Troy School District

**RFP #2425-09 - Addendum #1
BP#2B High School Athletics - Phase #2
January 21st, 2025**

Troy Schools District – RFP #2425-09 BP#2B High School Athletics Renovations - Phase #2

Addendum #1 Bidder Clarifications

C-2.0

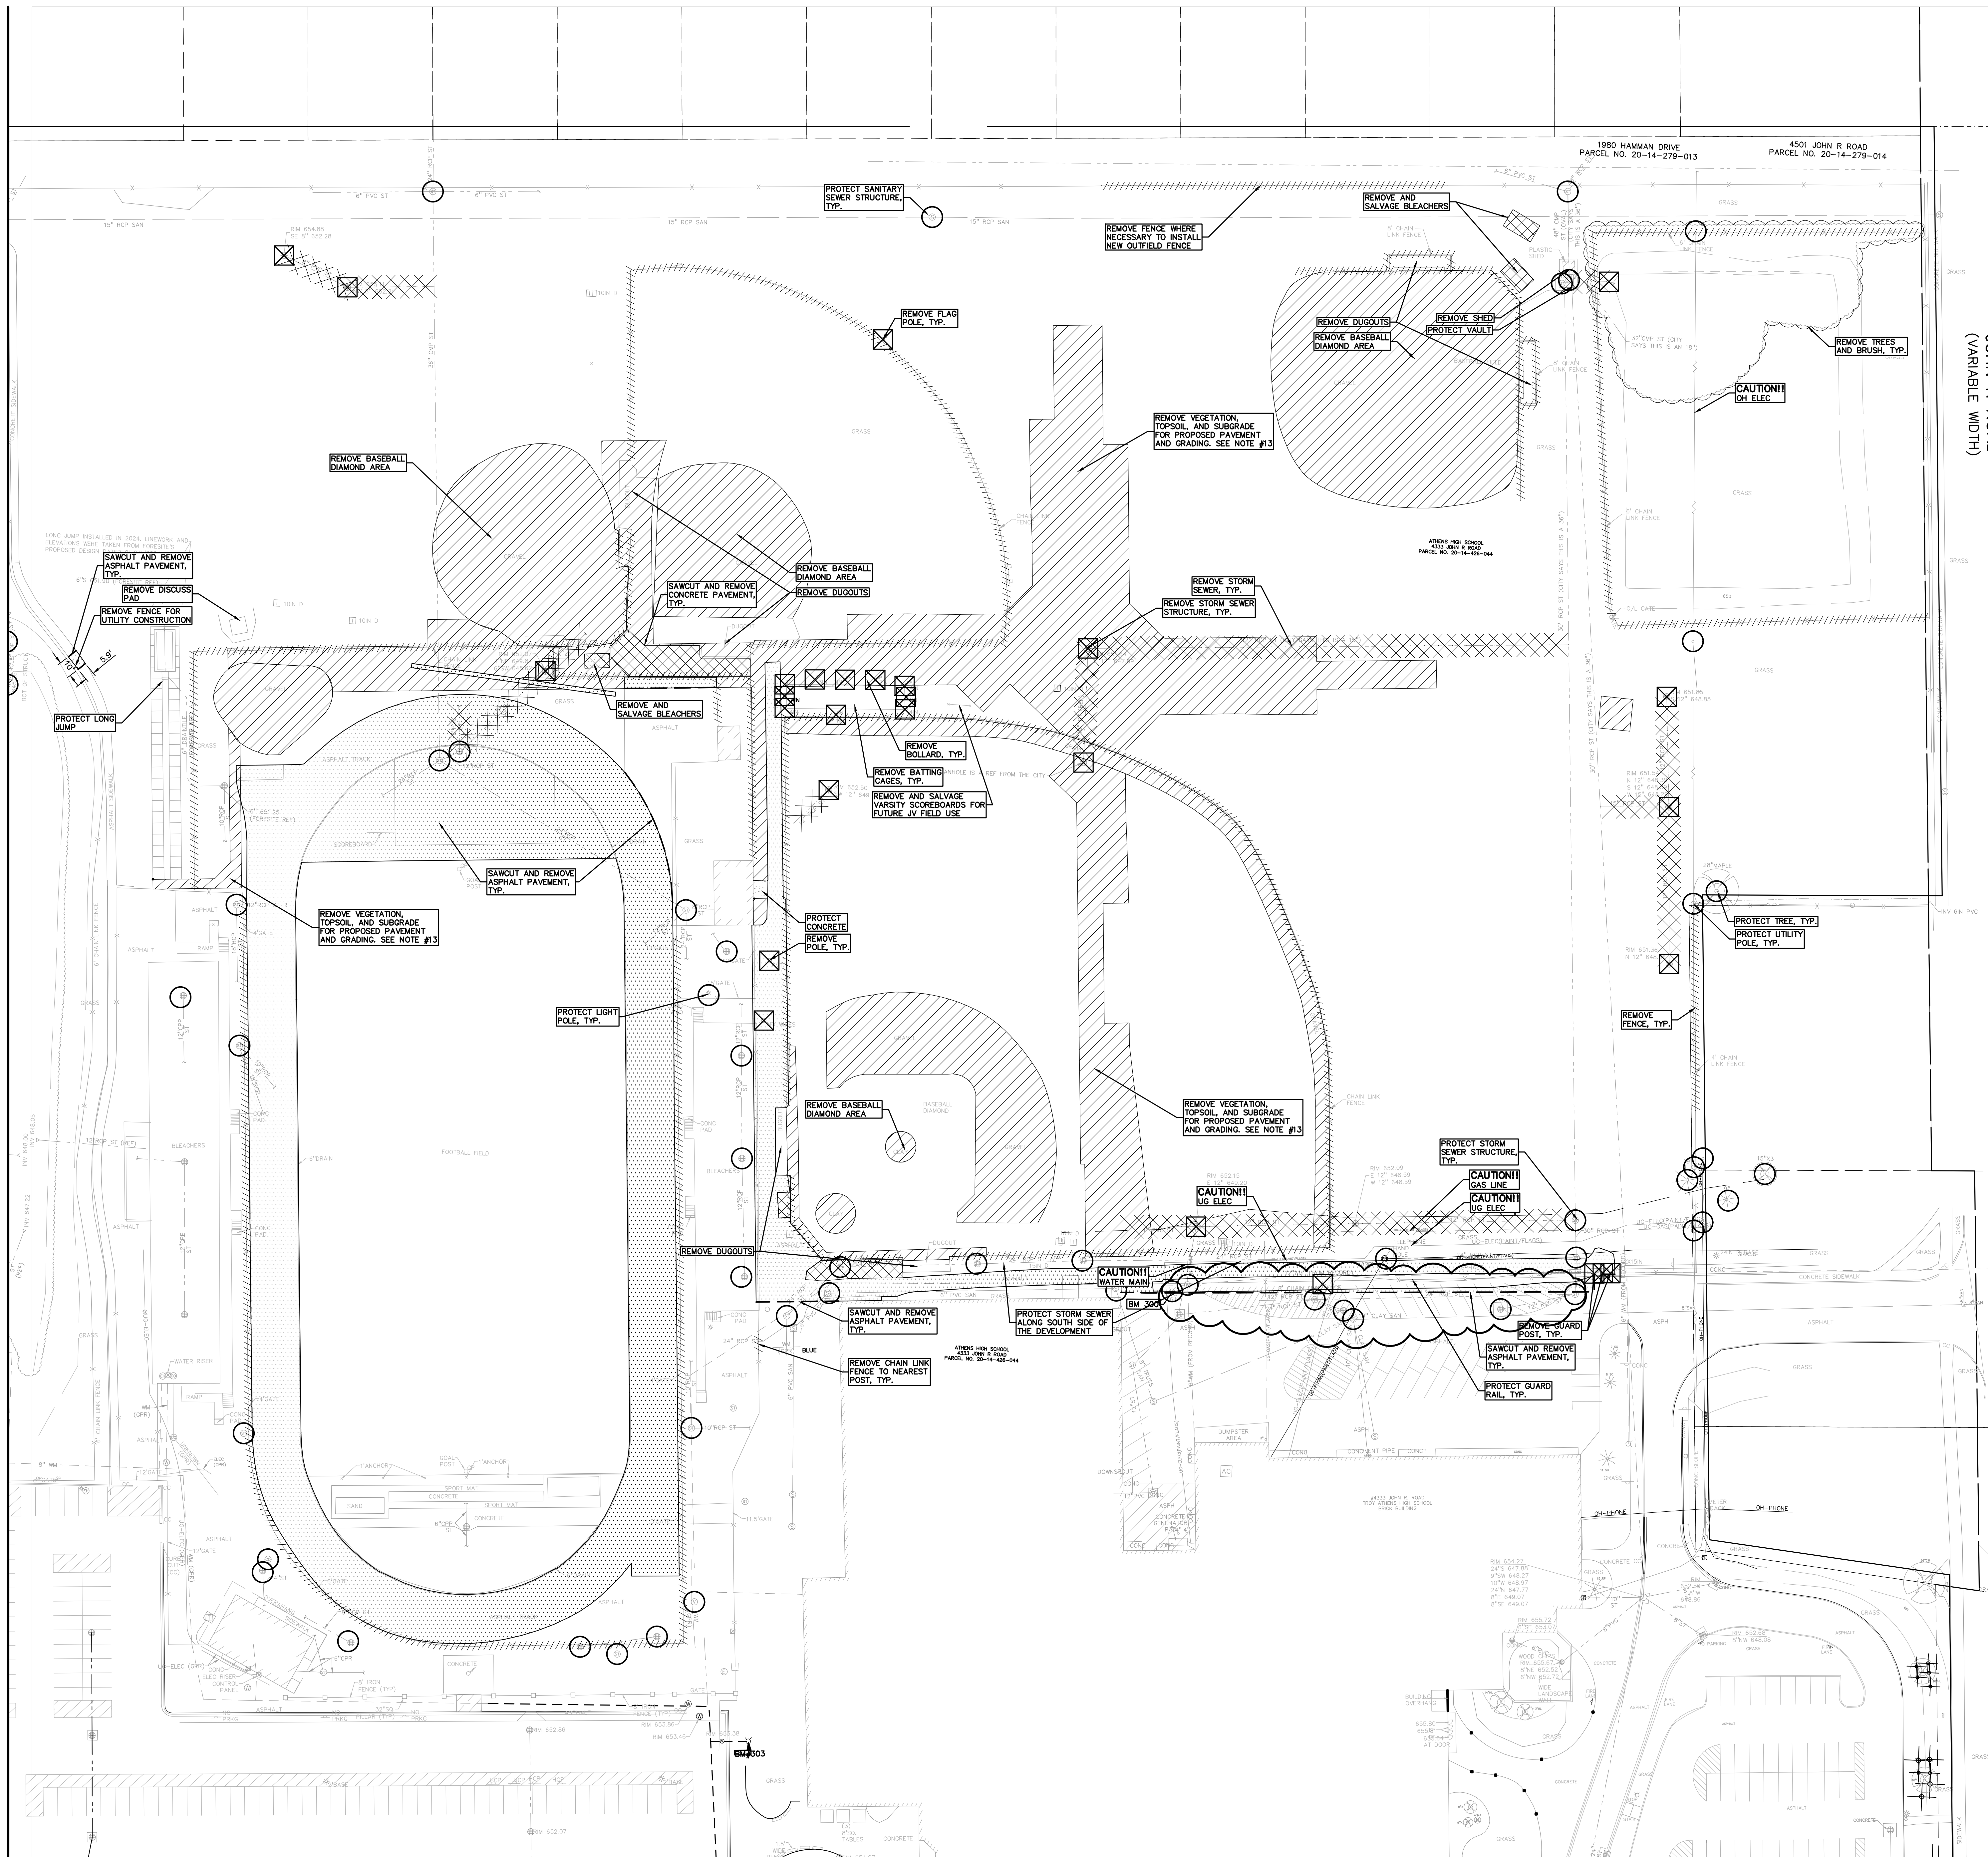
Q: Sheet C2.0 is showing an allowance to remove storm pipe of 200 lineal foot - where is this located on the plans?

Item No.	Civil Drawing Changes
CD-1	Refer to Drawing No. C2.0 (reissued): A. Added items to be protected/removed at the south end of the project limits as indicated. B. Added boundary to the “remove vegetation, topsoil, and subgrade” hatch as indicated.
CD-2	Refer to Drawing No. C3.0 (reissued): A. Added note referencing chain link fence at baseball outfield as indicated.

A: The revised construction documents issued in Addendum #1 show the storm sewers which are being removed on the demolition plan. Reference Addendum #1

DRAWING NO.
C-4.1

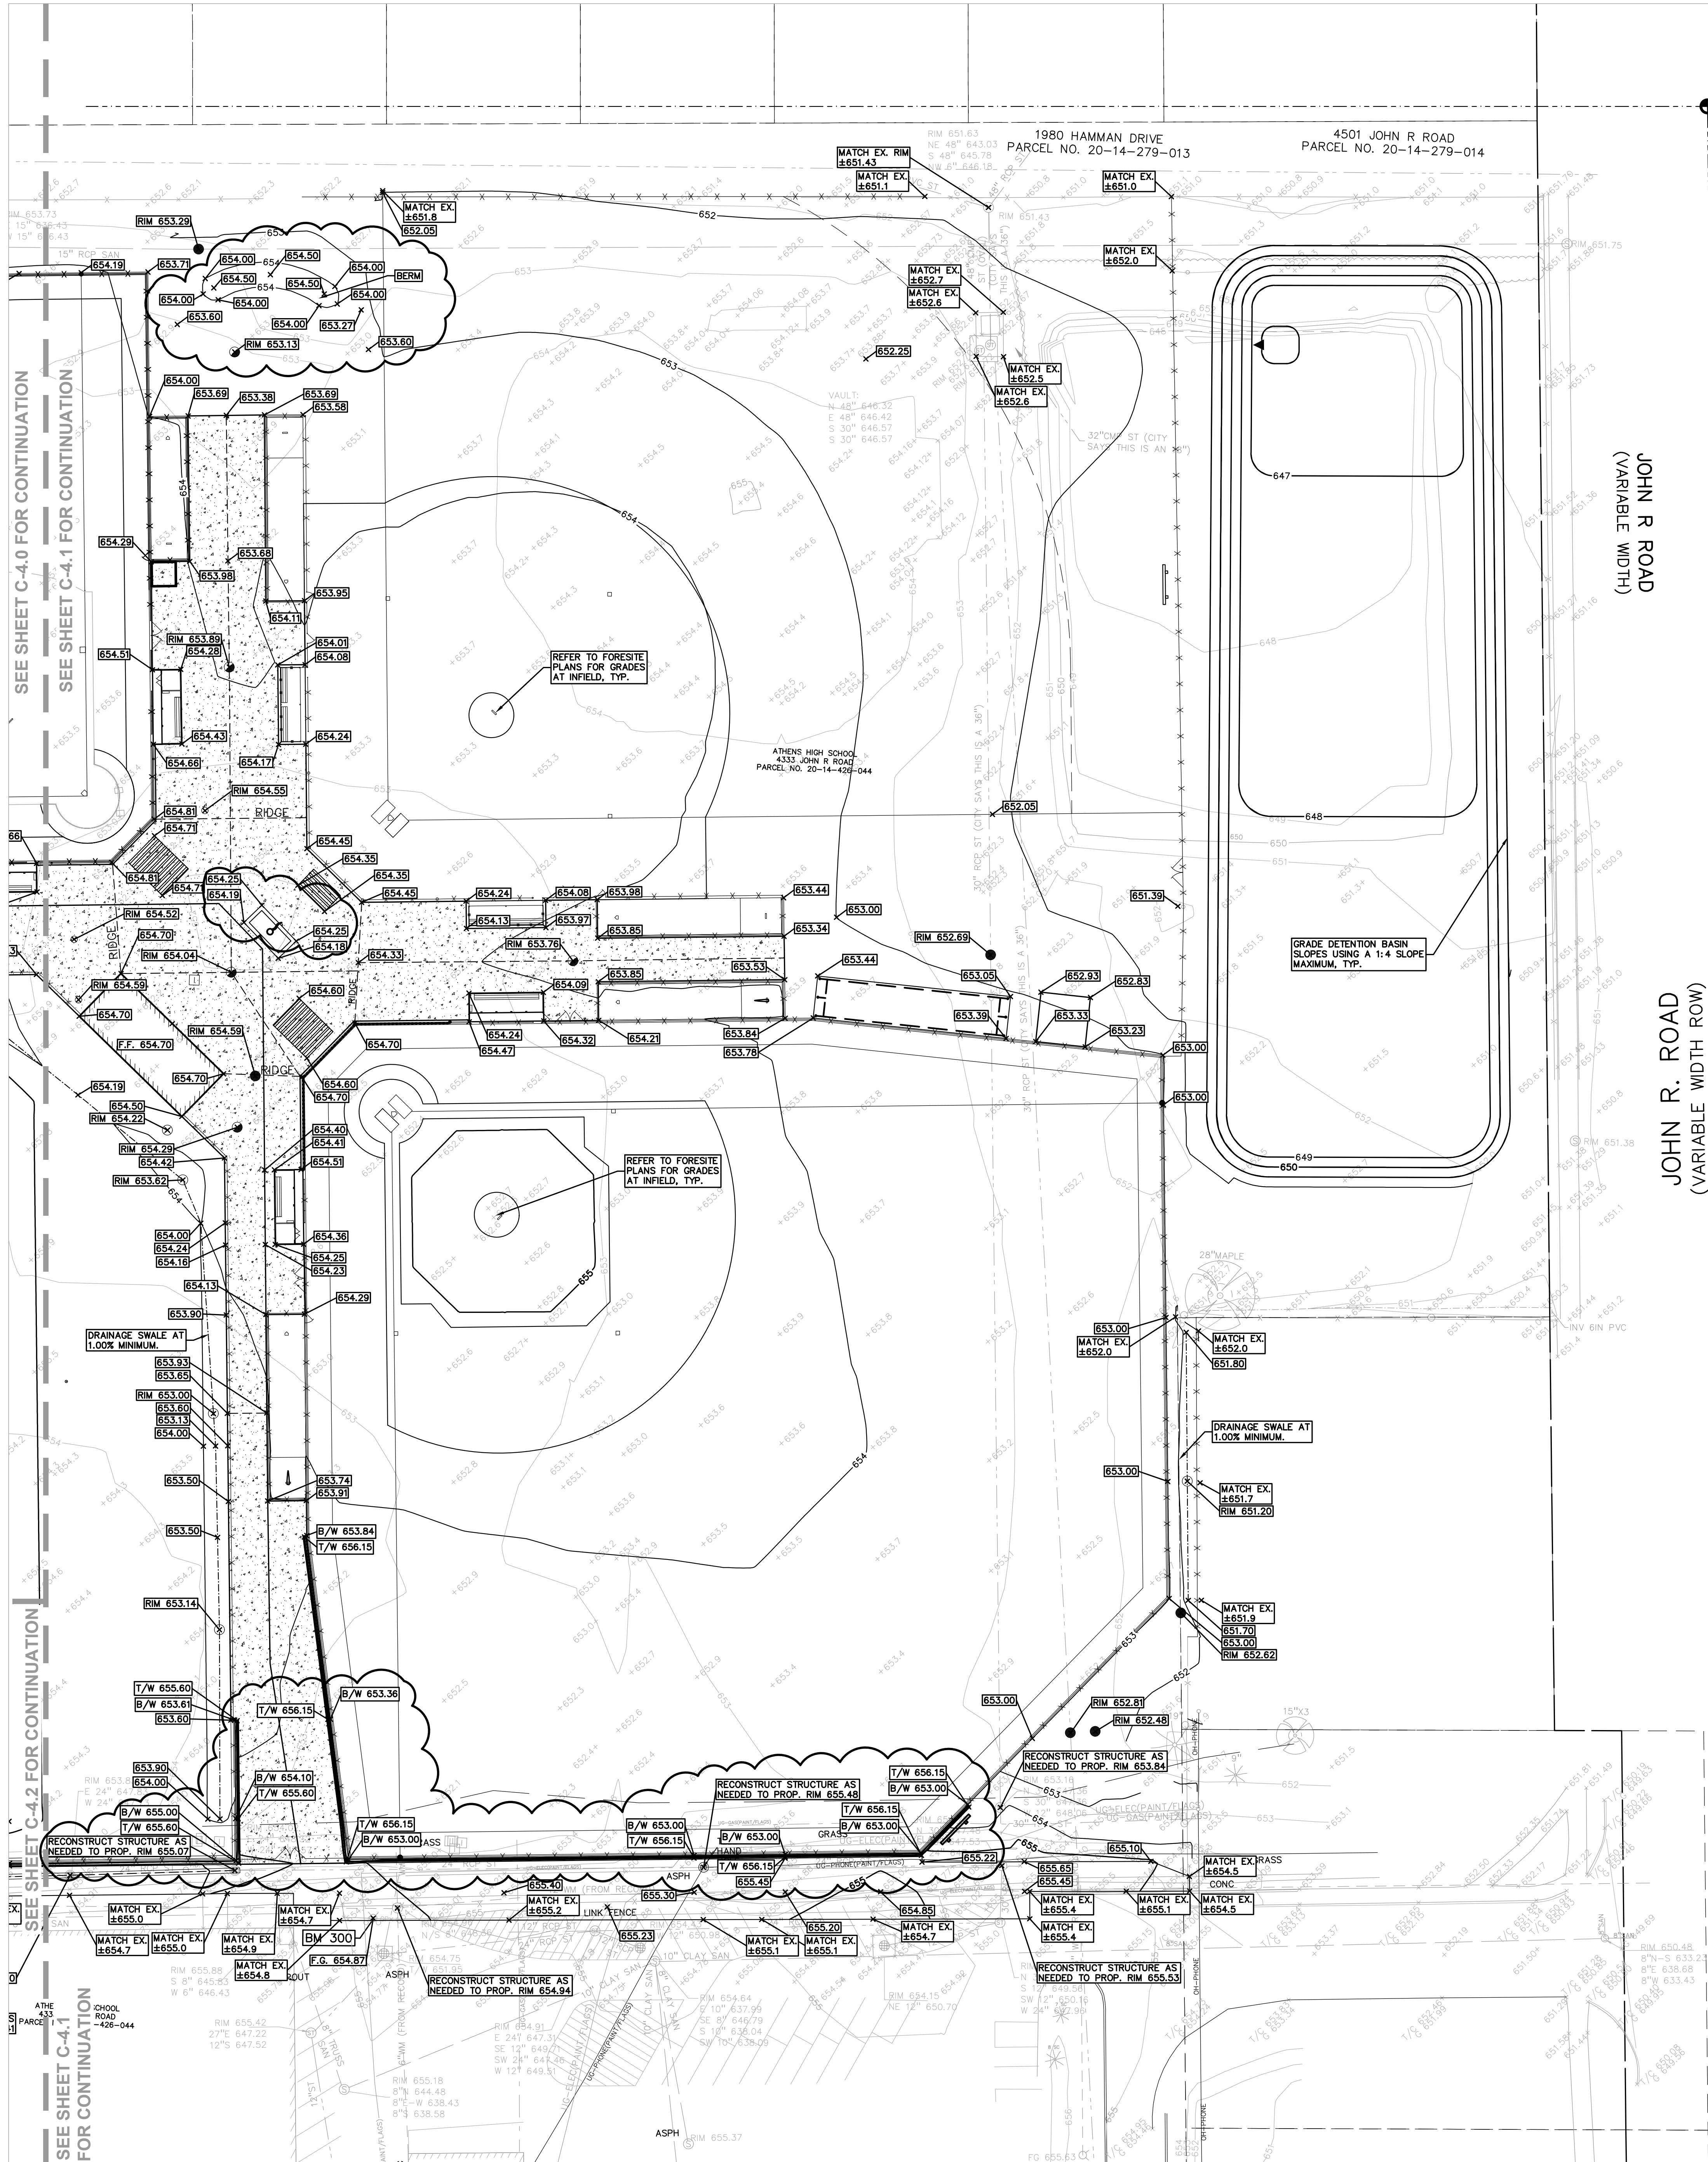
- CD-4 Refer to Drawing No. C4.1 (reissued):
- A. Revised grading around berm near varsity softball left field foul pole as indicated.
 - B. Revised grading at retaining walls between varsity baseball/practice field and concrete sidewalk as indicated.

- C. Added spot elevations around flagpole seat wall as indicated.
- CD-5 Refer to Drawing No. C4.2 (reissued):
- A. Revised grading at retaining wall between practice field and concrete sidewalk as indicated.

PROJECT NO.
22103D
DRAWING NO.
C-5.0

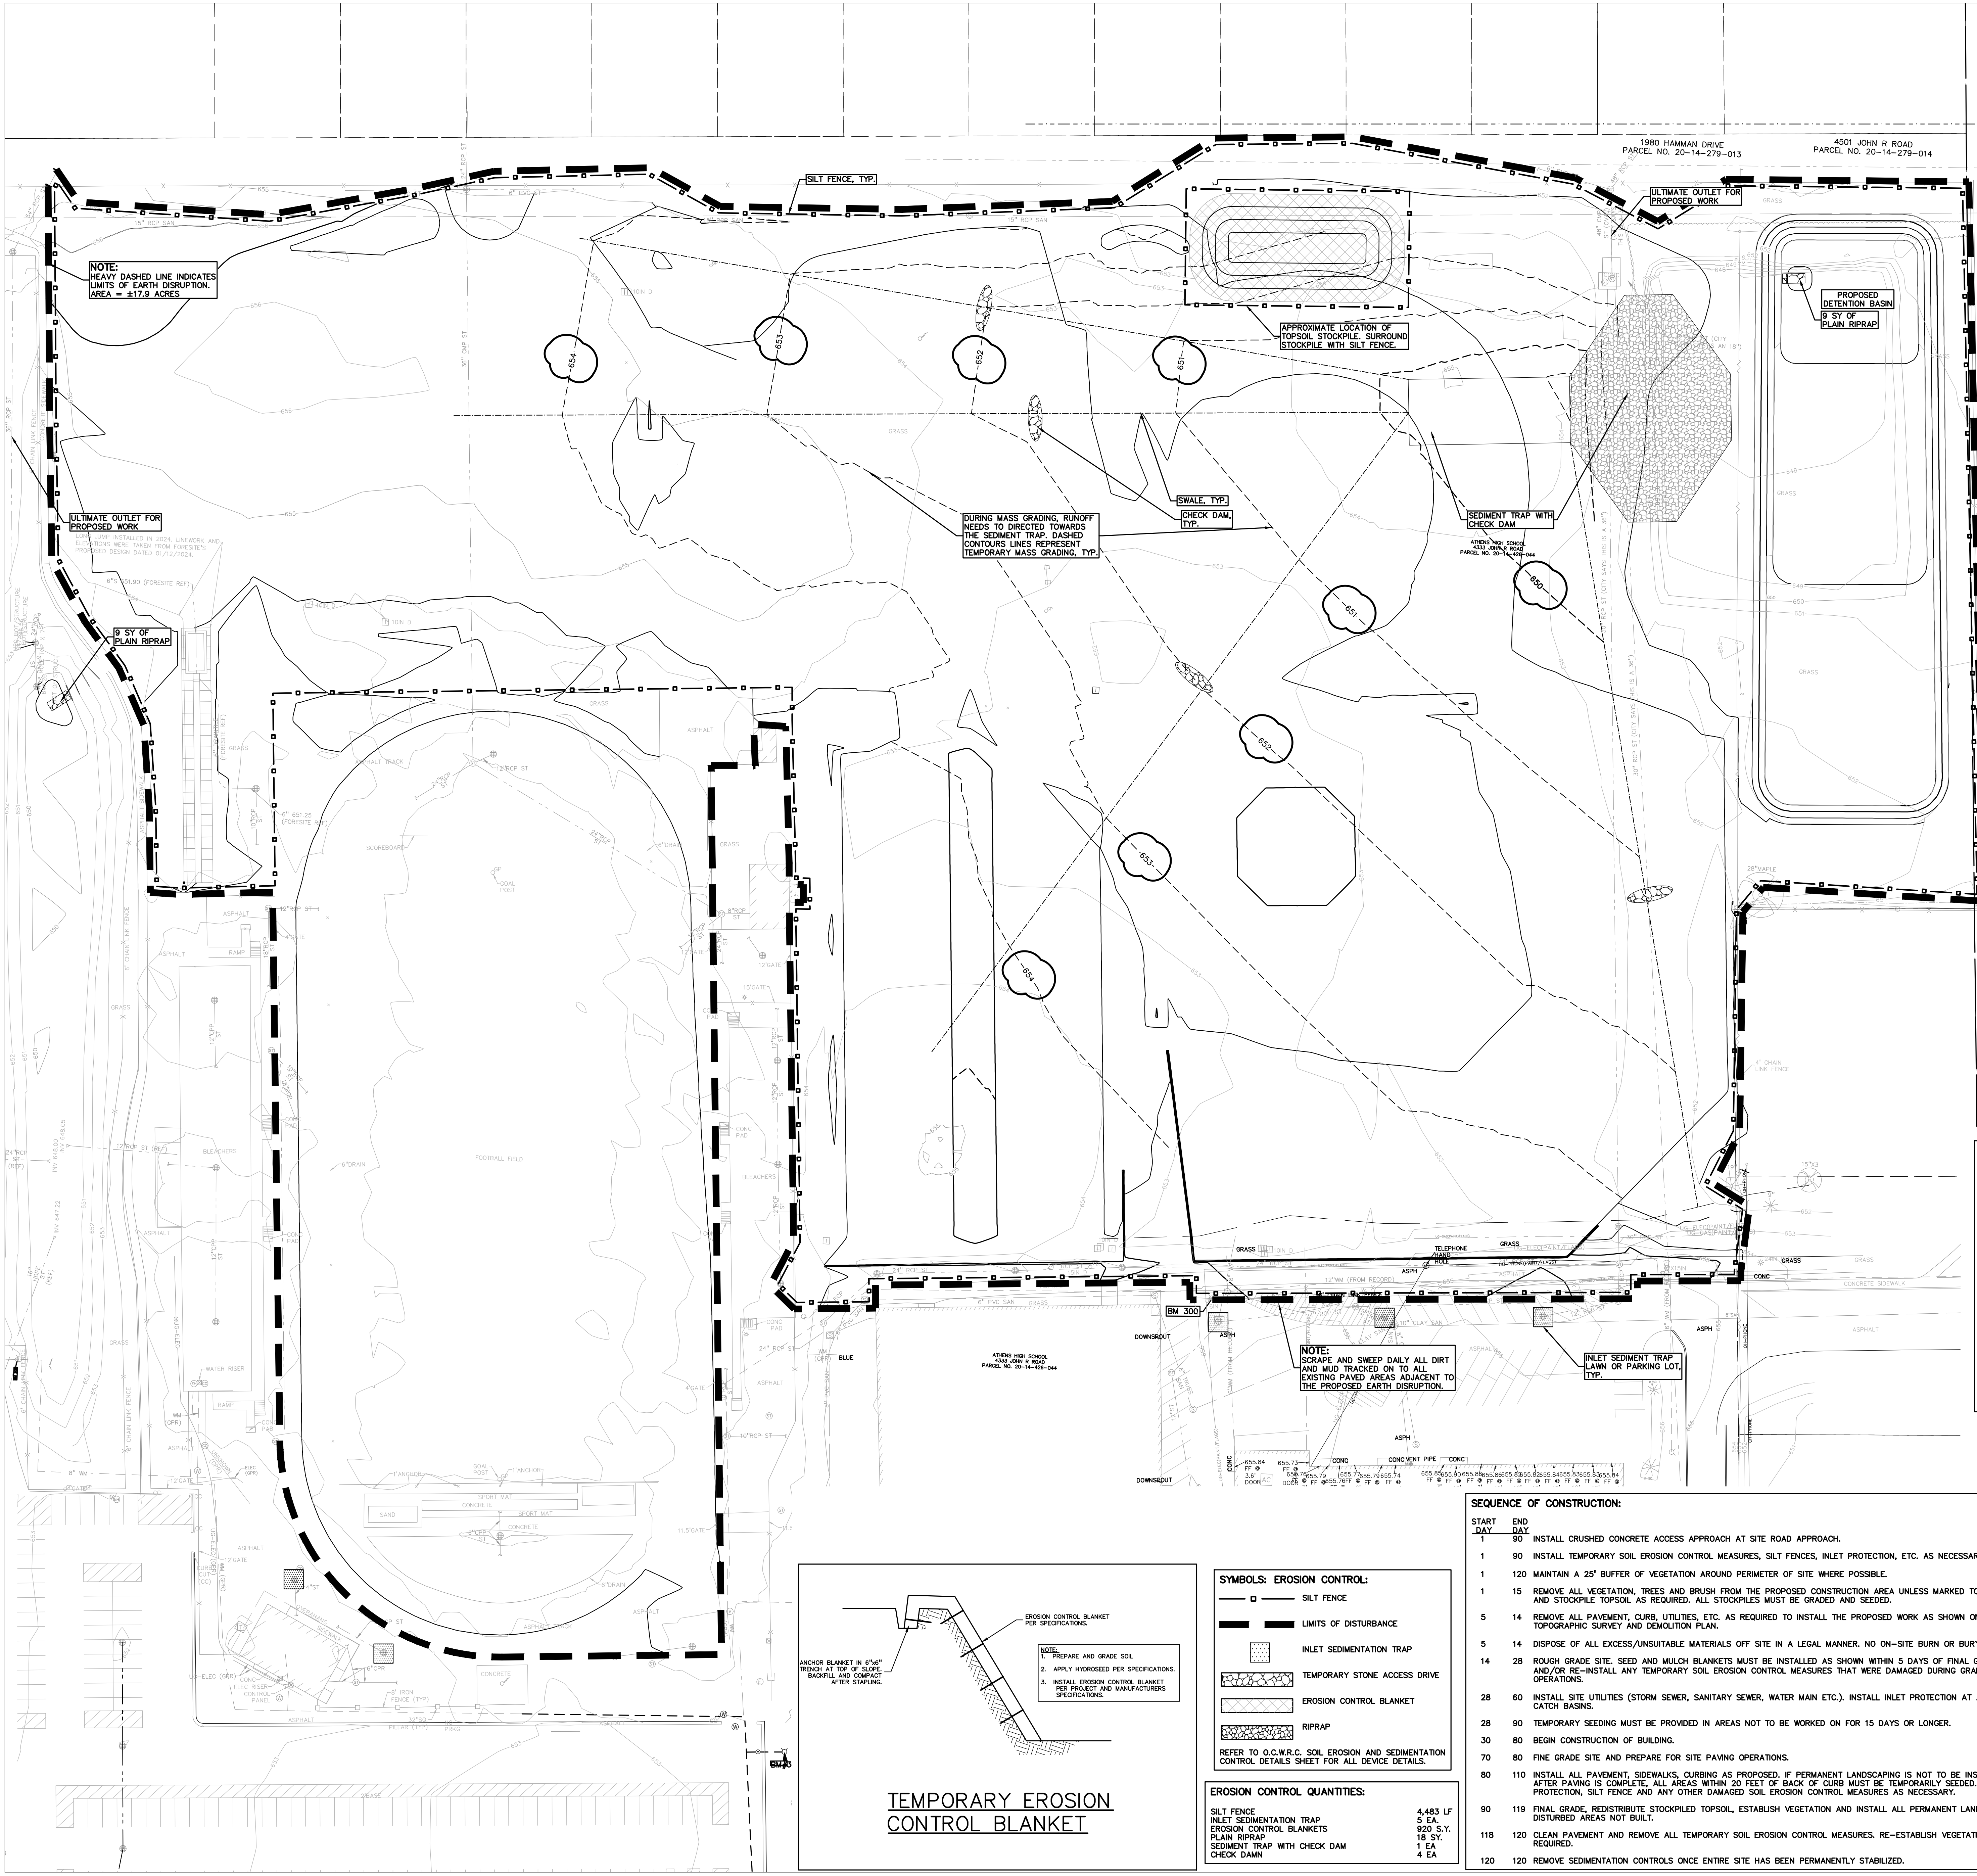
- CD-6 Refer to Drawing No. C5.0 (reissued):
- A. Added contour labels to the mass grading contours as indicated.
- CD-7 Refer to Drawing No. C5.1 (reissued):
